Public Hearing for Southport East Replat 13

RECOMMENDATION REPORT

CASE NUMBER: 2014-PUD-01; 2014-SUB-01 FOR HEARING OF: March 27, 2014
Report Prepared on: March 14, 2014

RE: Preliminary PUD, Preliminary Plat, Final Plat -Initial Review
Southport East Replat Thirteen

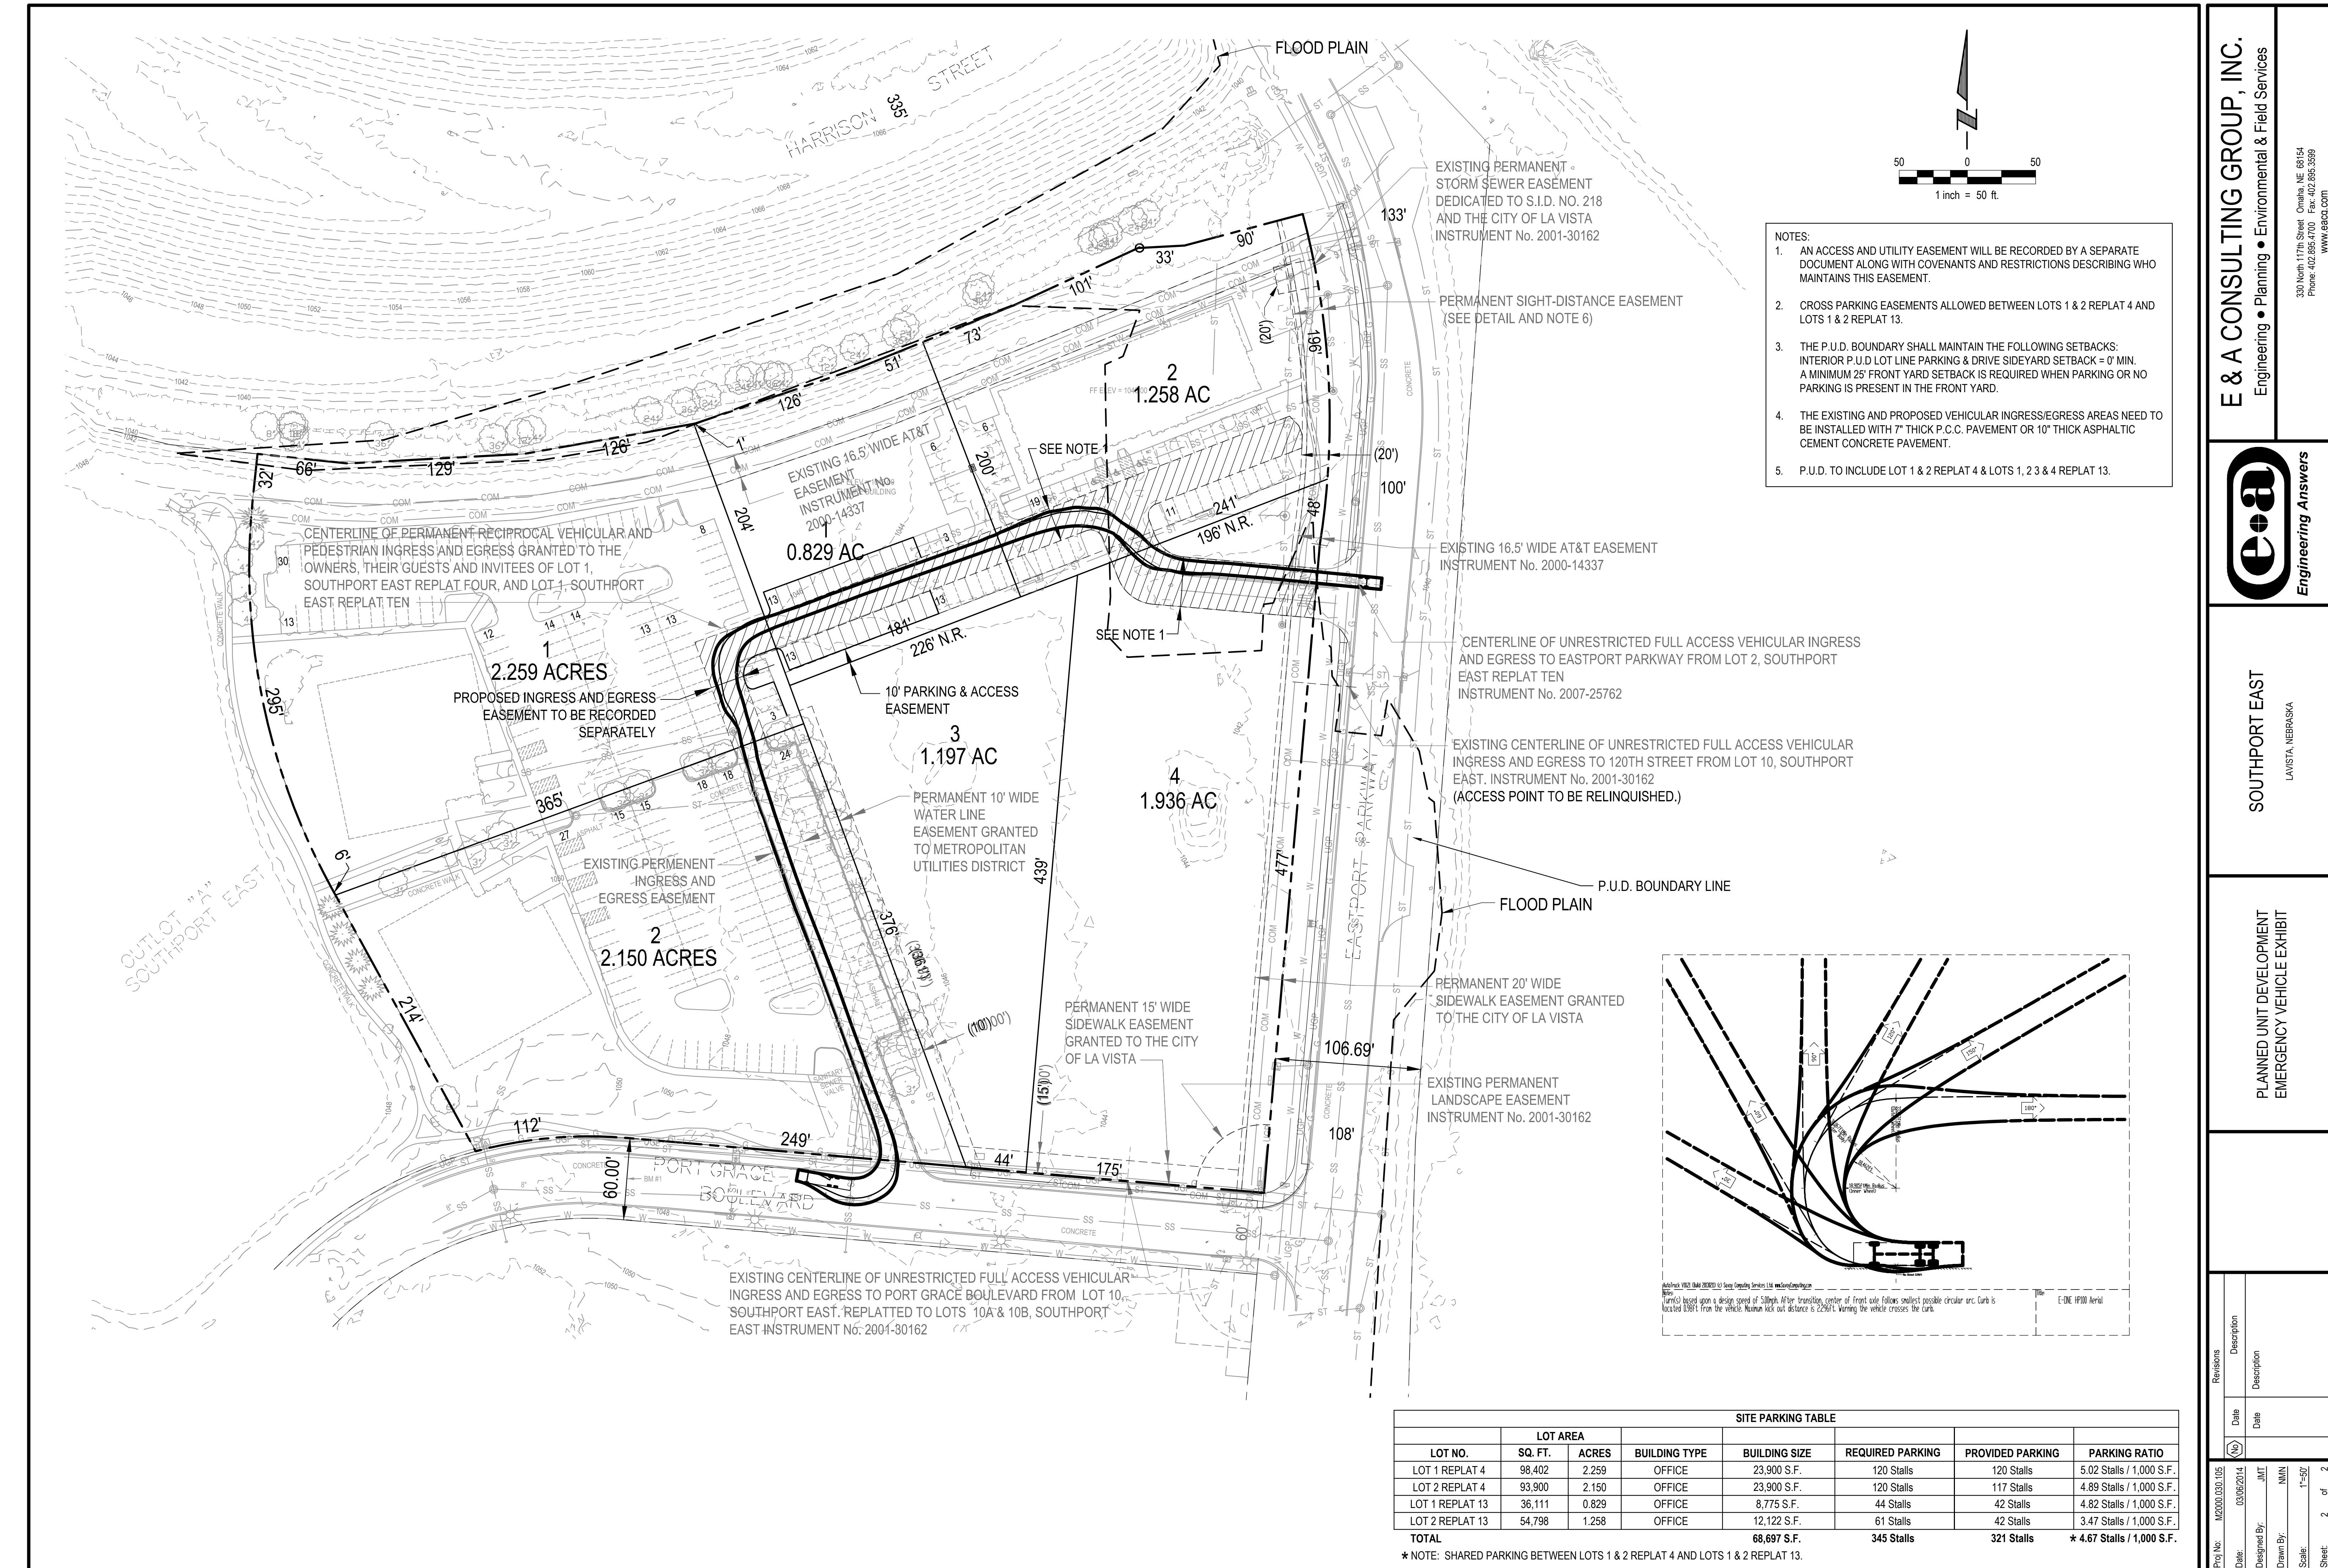
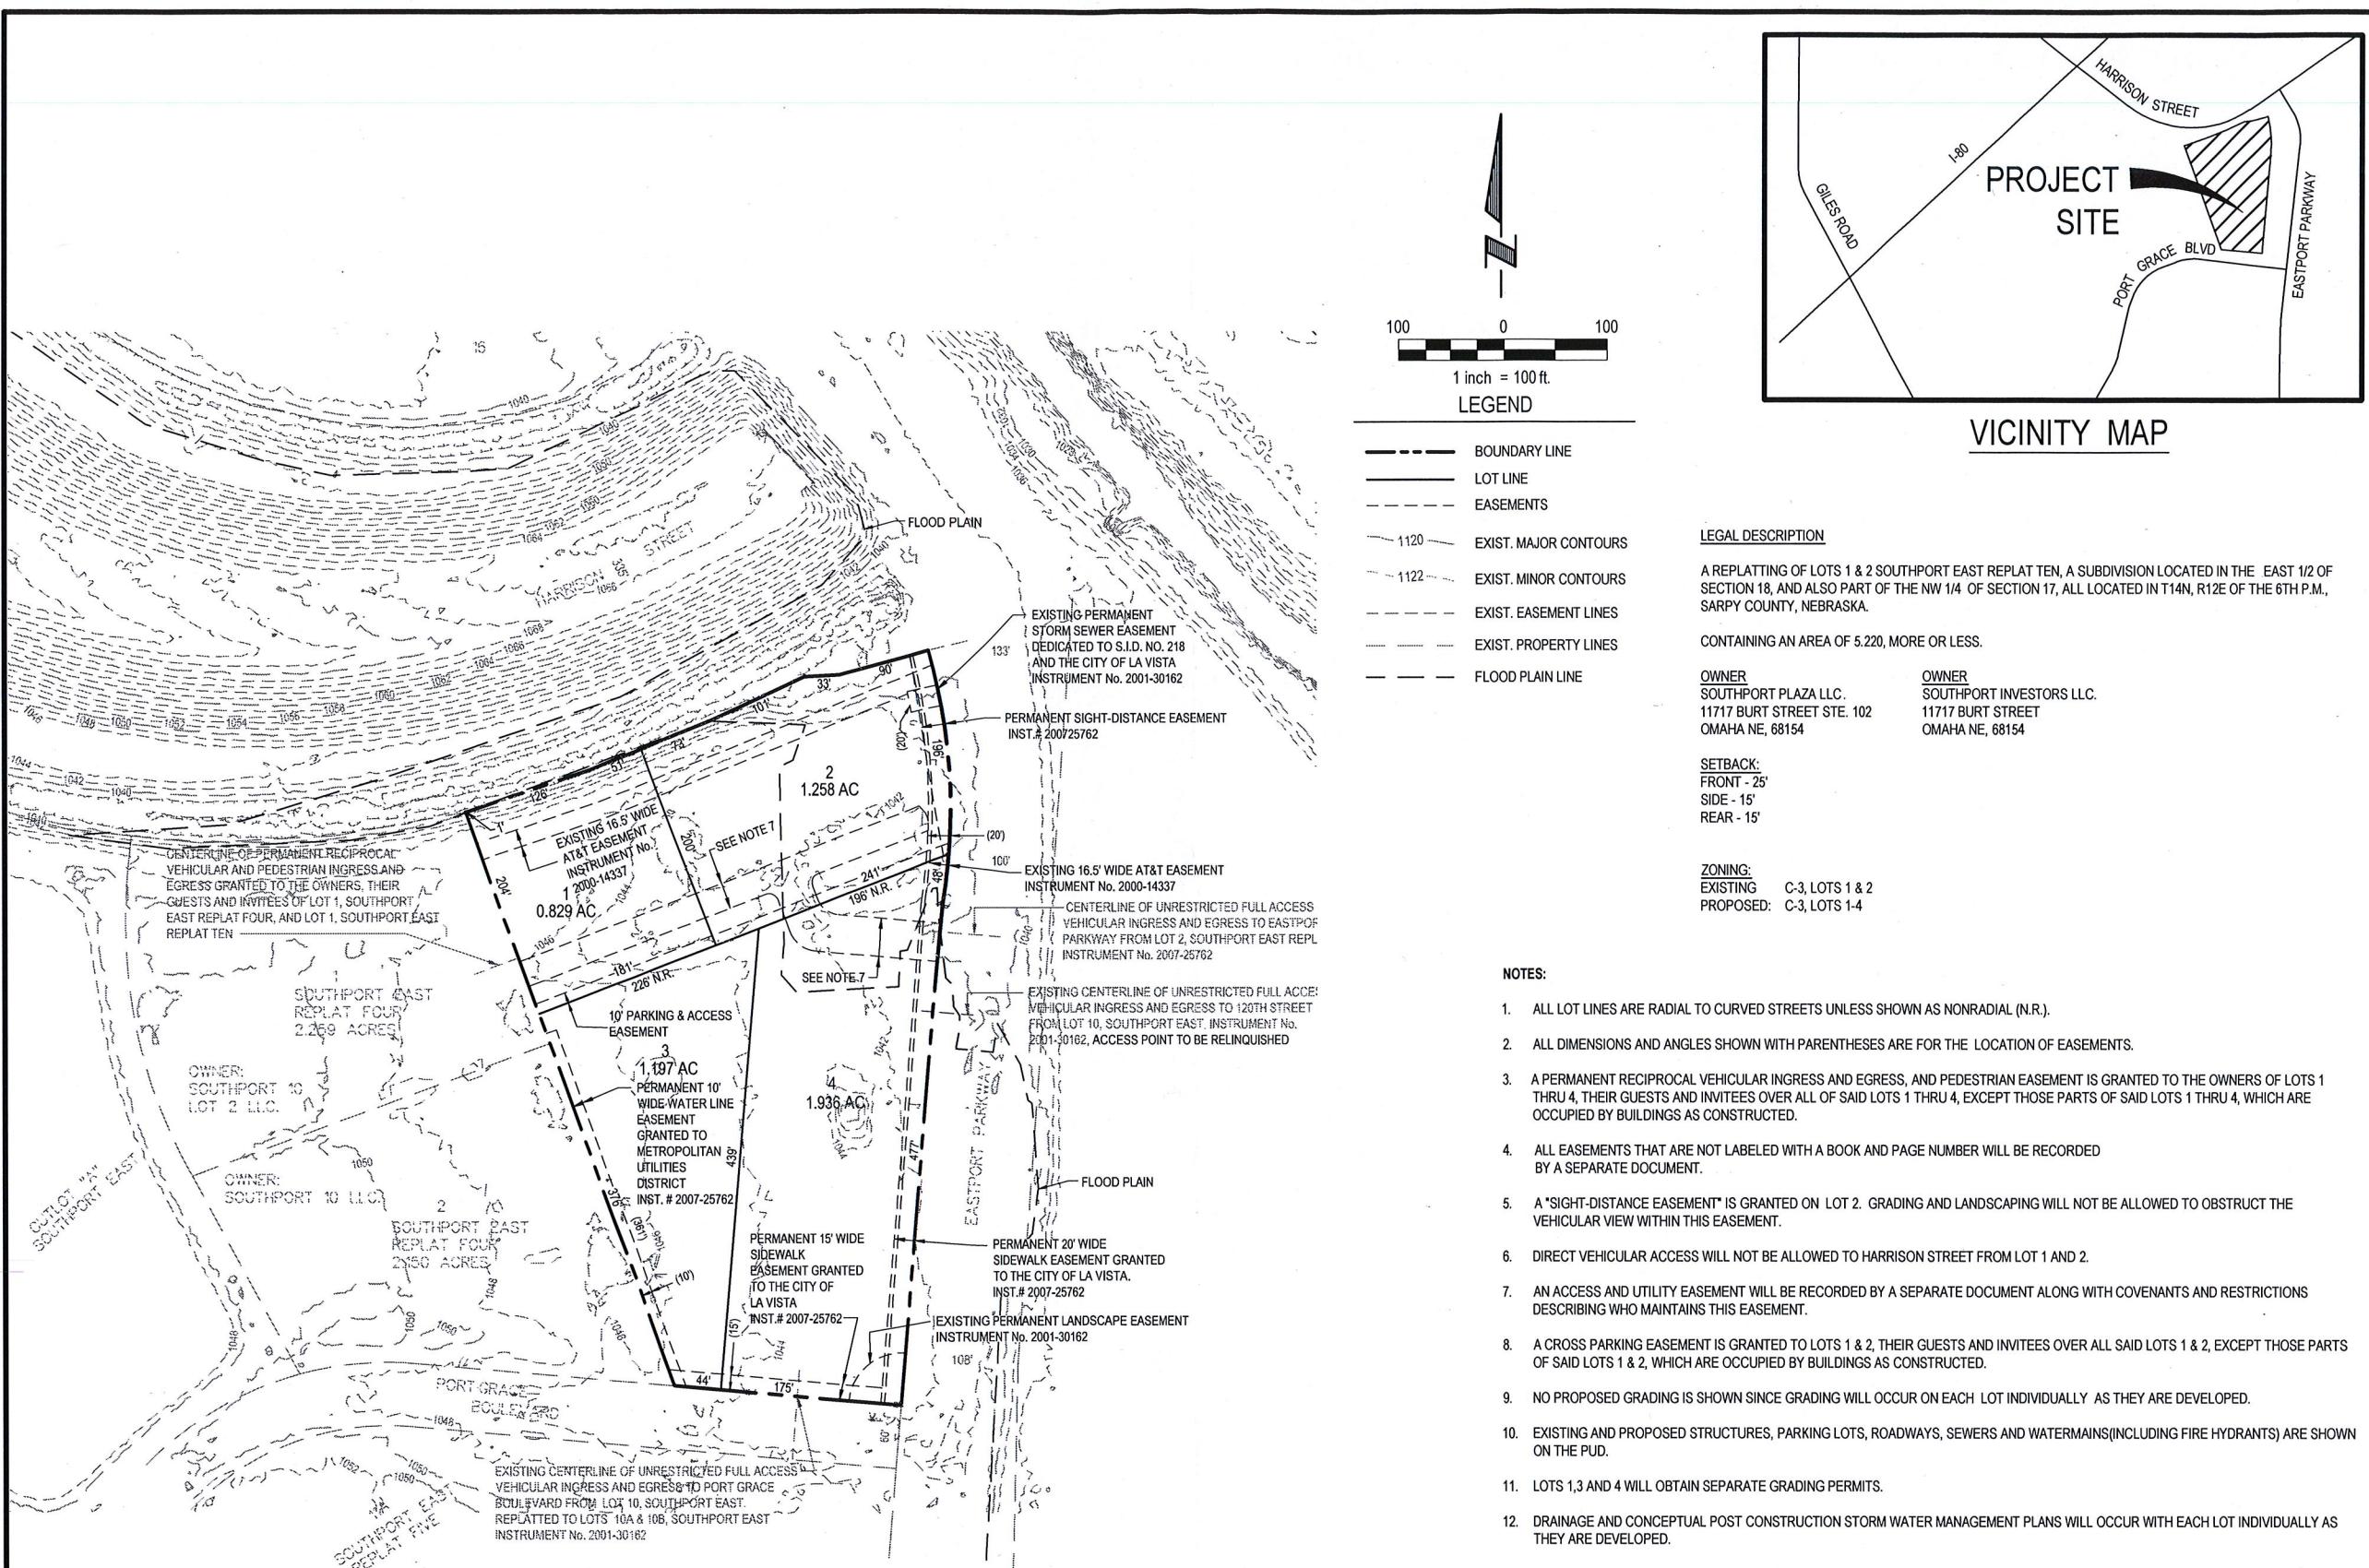
2. The Site Parking Table on the PUD Site Plan needs to be amended to address the parking count (required and provided) for the daycare and personal improvement uses currently occurring in the existing building on Lot 2, Replat 13 as they may exceed the requirements for the shown office usage.

Also, the data table shows the provided parking count of 84 stalls for Lots 1 and 2 of Replat 13. The site plan currently shows 58 existing parking stalls on these two lots, so there would need to be 26 additional stalls as part of the development of Lot 2, Replat 13 which may limit how much building can be constructed on this lot. The applicant needs to confirm through a note on the PUD Site Plan that development on Lot 2 can provide the additional 26 stalls needed to meet the stated stall count.

3. The existing sanitary sewer service lines to the existing buildings on Lots 1 and 2 of Replat 4 need to be added to the PUD Site Plan.
4. Item 13 within the original Southport East subdivision agreement states that sidewalks along 120th Street (Eastport Parkway) may be deferred until the City determines that there is a need for their construction. A maximum time period for the installation for the public sidewalks and the corner feature should be a maximum of 5 years from the date of approval of the final plat. This will be noted in the review comments of the subdivision agreement.
